**COUNTY OF SAN MATEO
PLANNING AND BUILDING DEPARTMENT**

SUBJECT: EXECUTIVE SUMMARY: Consideration of an appeal of the Director of Planning and Building's decision to adopt an Initial Study/Mitigated Negative Declaration (MND) pursuant to the California Environmental Quality Act (CEQA) and approve a Design Review Permit, Coastal Development Permit (CDP), and Grading Permit, for the construction of a new 2,653 sq. ft., three-story, single-family residence with attached 625 sq. ft. garage on a legal 6,000 sq. ft. parcel located at the corner of 15th Street and East Avenue in the unincorporated area of Montara. The project includes the removal of 19 significant trees and 435 cubic yards (c.y.) of grading (300 c.y. of cut and 135 c.y. of fill). The CDP is appealable to the California Coastal Commission.

County File Number: PLN2014-00490 (Wilkins)

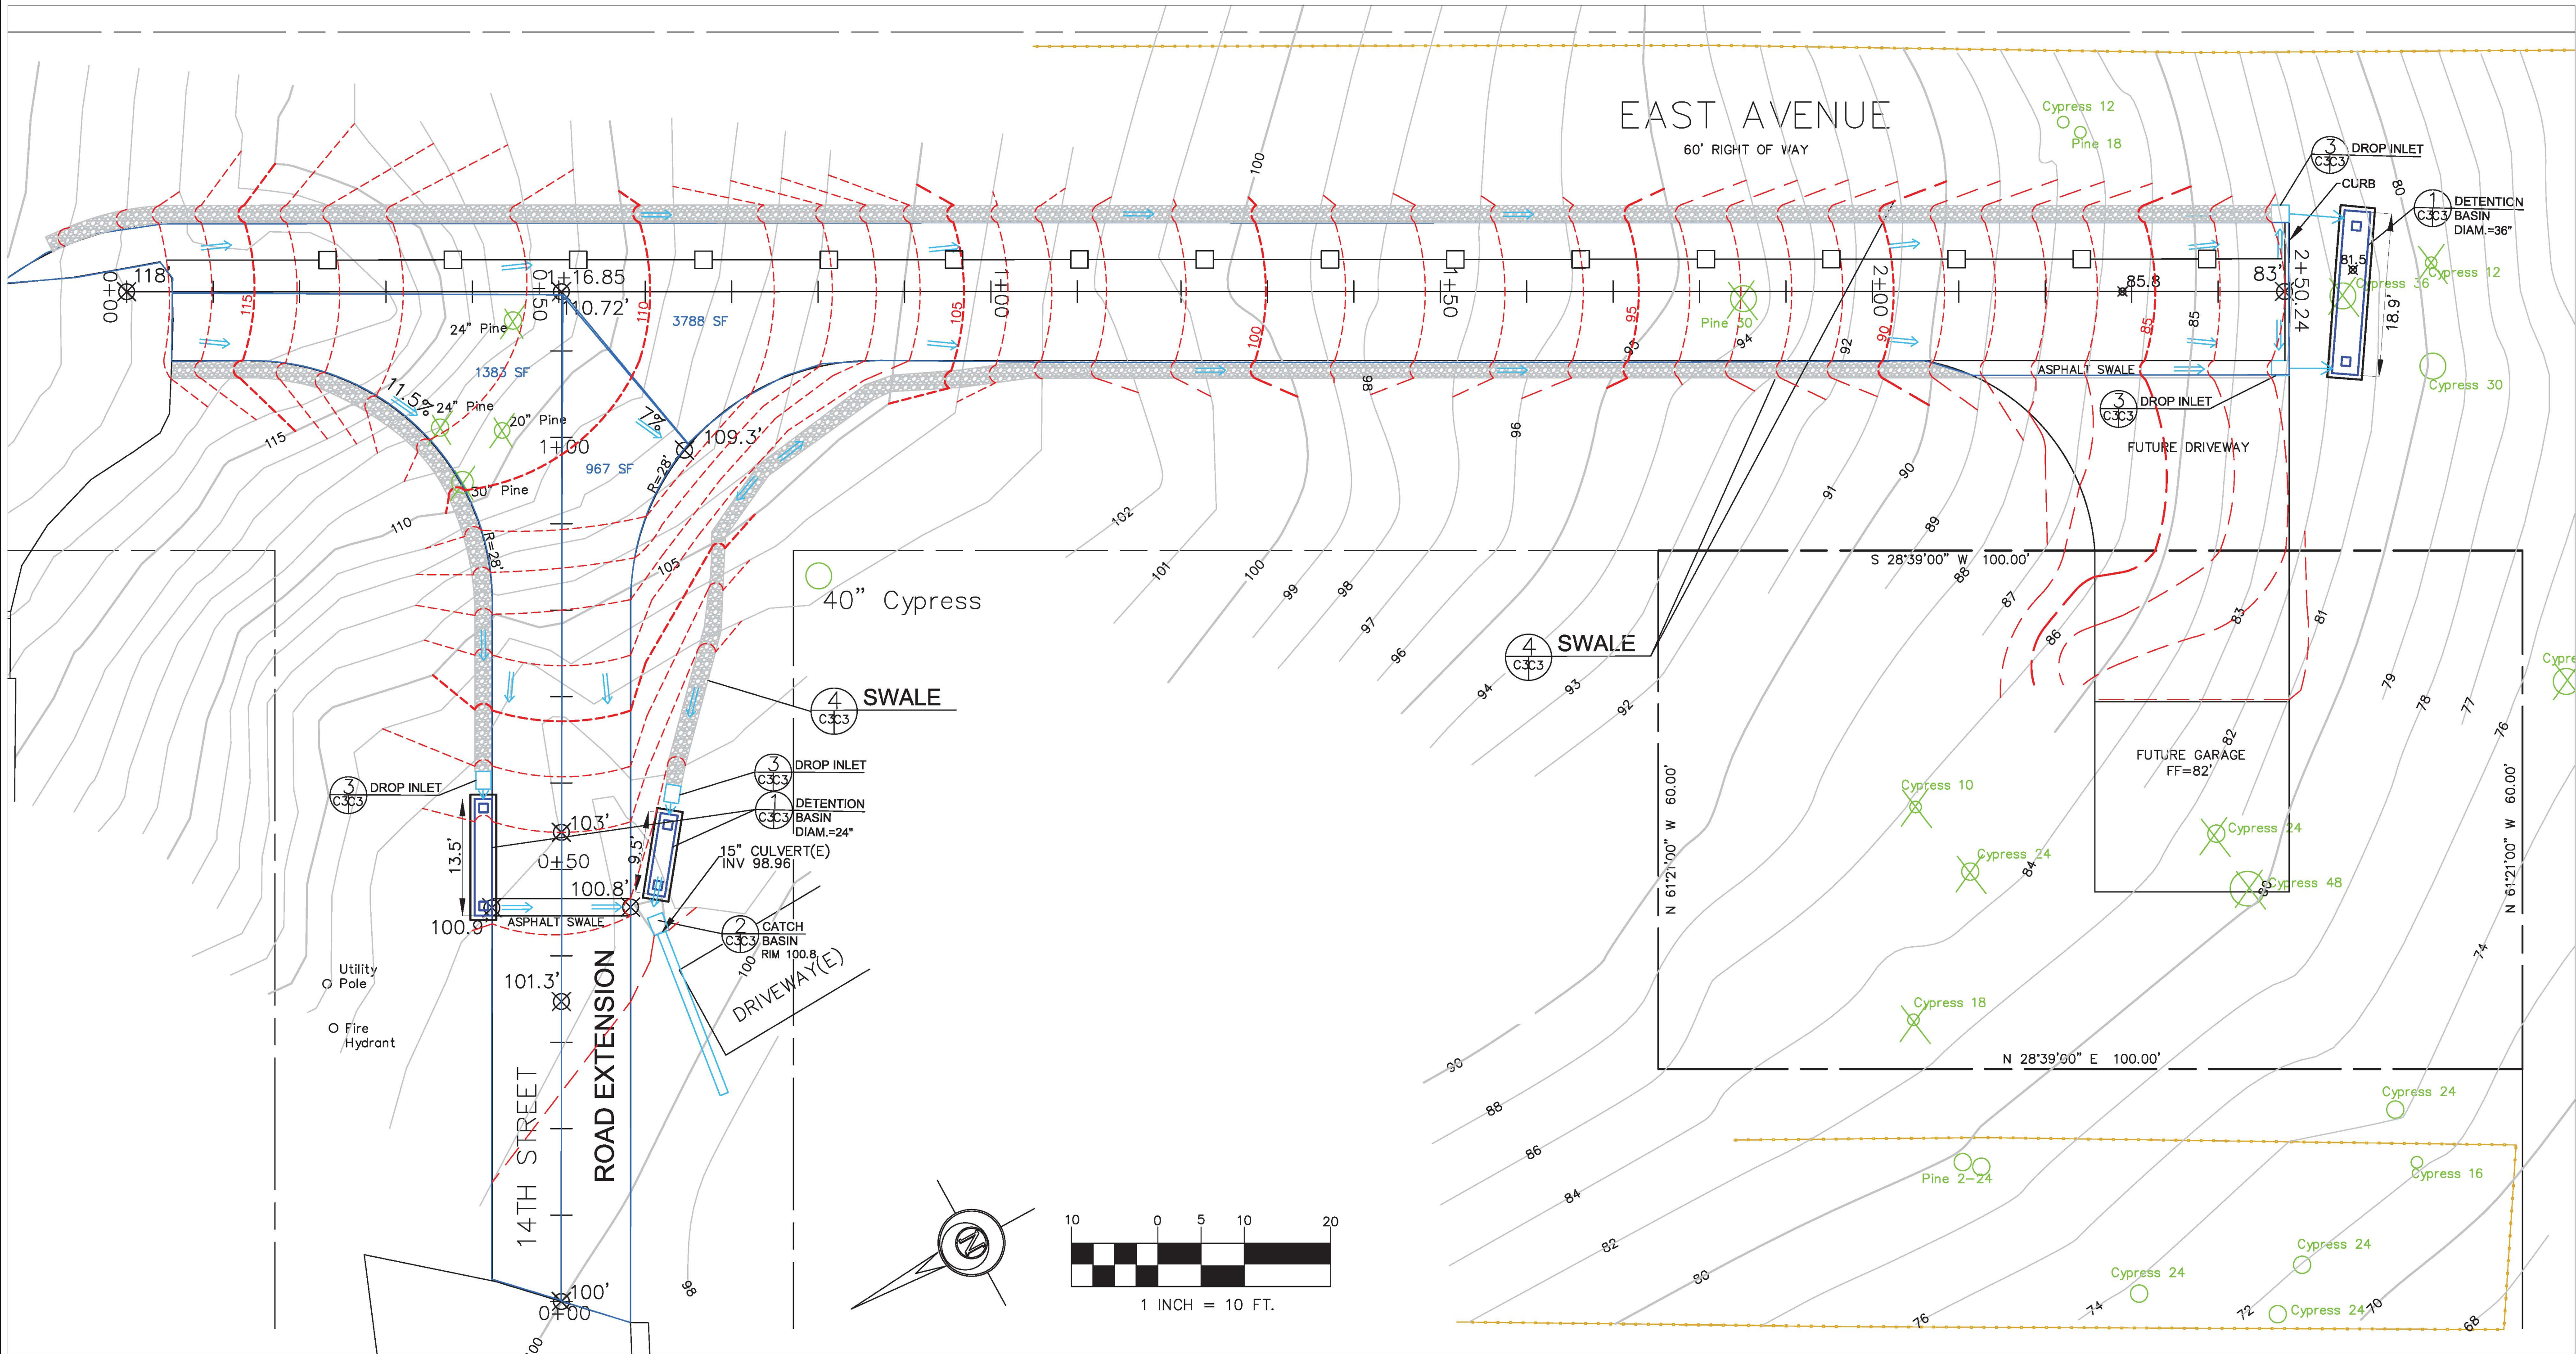
Sheet C-1 of the project plans (which is included with the other project plans provided by the County) identify the site as being located at “14th Street and East Ave.” The referral and reduced set of plans state it is on 15th Street. Please clarify the location and ensure that it is consistent on subsequent project plans (and communications). 14th and 15th Streets are “paper streets” and respectively currently partially developed or undeveloped. East Street is undeveloped/unpaved heading south from 10th Street. The parcel is located in an area zoned as R-1/S-17/DR/CD; therefore the proposed project must be evaluated for consistency with the development standards and requirements of the current Design Review and Coastal Development zoning districts.

Project Plans and information in the referral indicate that five cypress trees would be removed. Review of plan sheet C-1 shows that an additional tree, 30 inches in diameter is located within the footprint of the road extension, therefore a total of six trees will be removed.

Figure 3. Special Status Plant Occurrences within 2-miles of Study Area

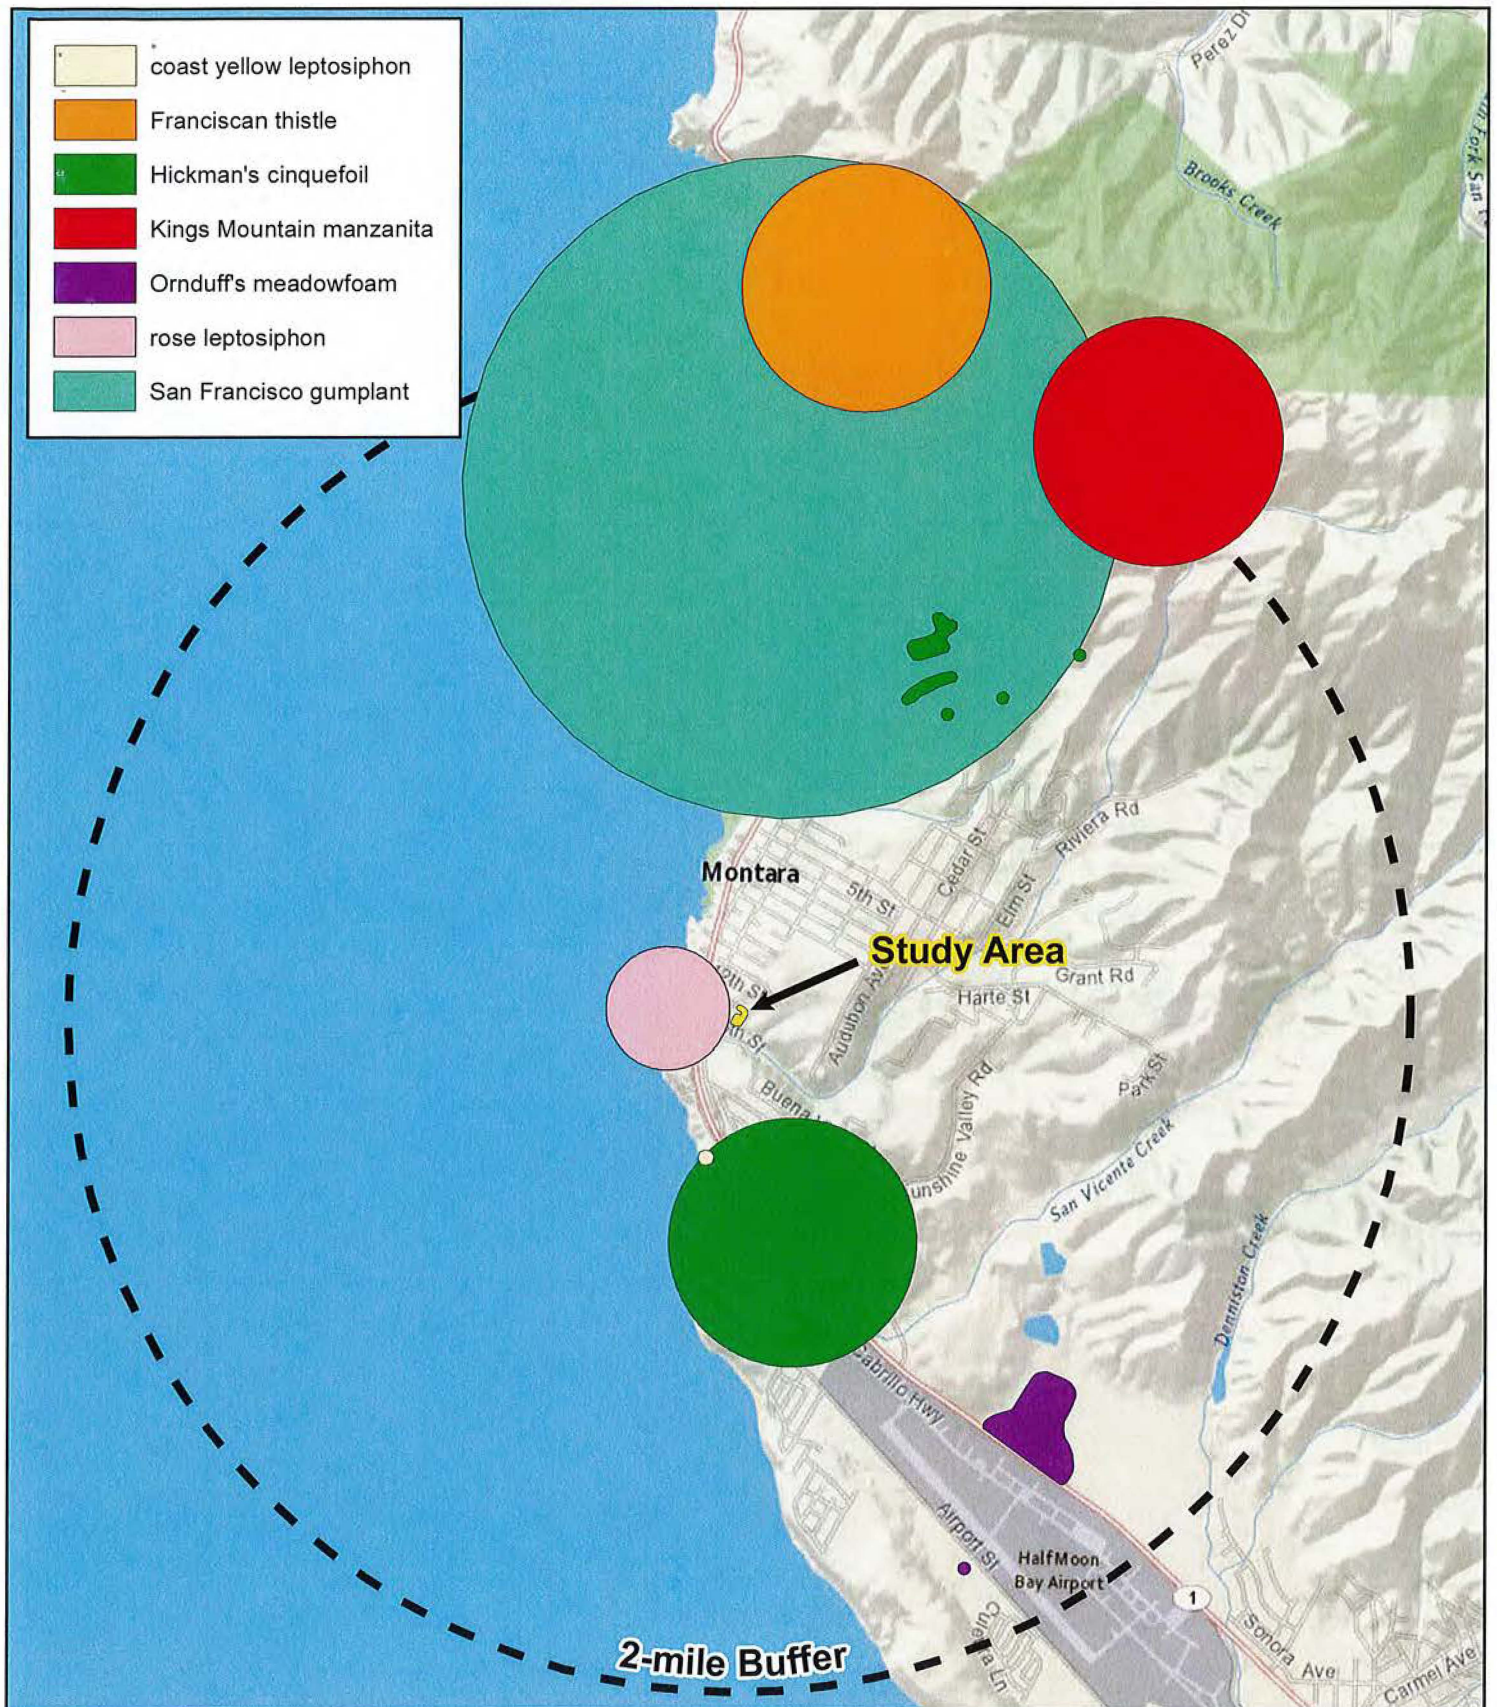
Figure 3 of WRA's August 7, 2015 shows *Leptosiphon rosaceus*, a ranked special-status CNPS 1B.1 species, potentially occurs in the vicinity of the proposed project site. This plant species typically blooms from April through July. Therefore, it may not have been observed during the plant surveys that were conducted in March and late July. We recommend that an additional survey be performed within this species' blooming period.

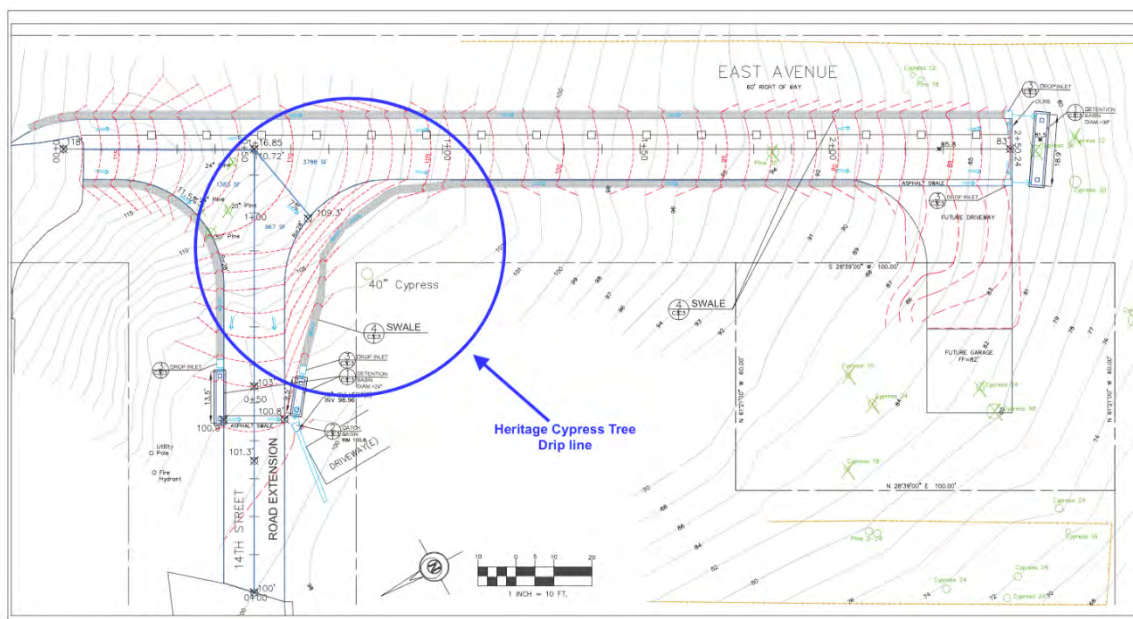
The diagrams and pictures below depict the totality of the drip line over the proposed driveway, and clearly show that the proposed route would effectively circle two hundred and seventy (270) degrees around the base of the Heritage Cypress Tree. The tree is an integral part of our home and neighborhood and its prospective removal or harm, including any removal of the tree roots system, is contested. Indeed, because of the precise location of the tree, its destruction appears to be the most likely result of the project as planned. The developer's planned road and grading construction would ultimately weaken the tree, thus presenting a high probability that the tree might fall and seriously damage our home, neighboring homes, or possibly cause other types of damages, including severe injury or death of persons and impacted wildlife.

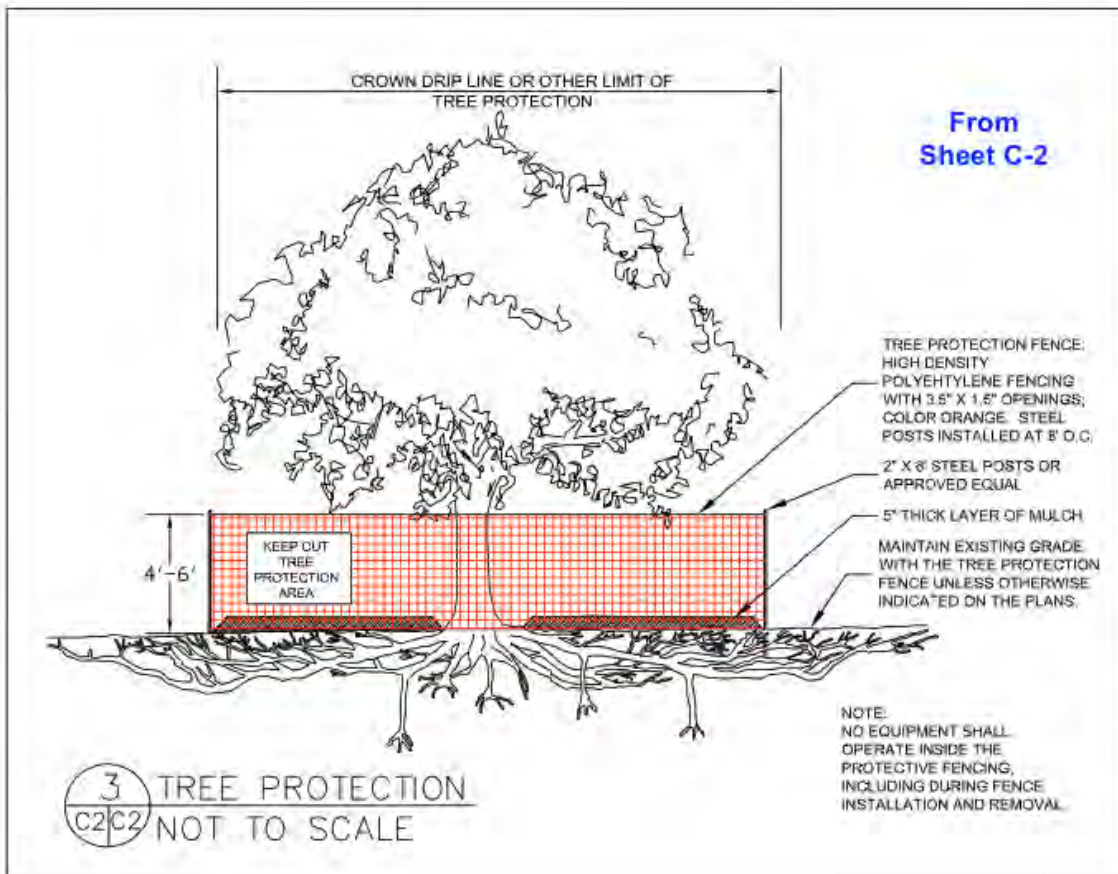
The developer's tree protection plan (see below) shows installing polyethylene fencing at the tree drip line not allowing any work to happen within that zone. The driveway cannot be installed with this protection plan in place. The developer designed tree protection plan makes this driveway installation non-feasible.
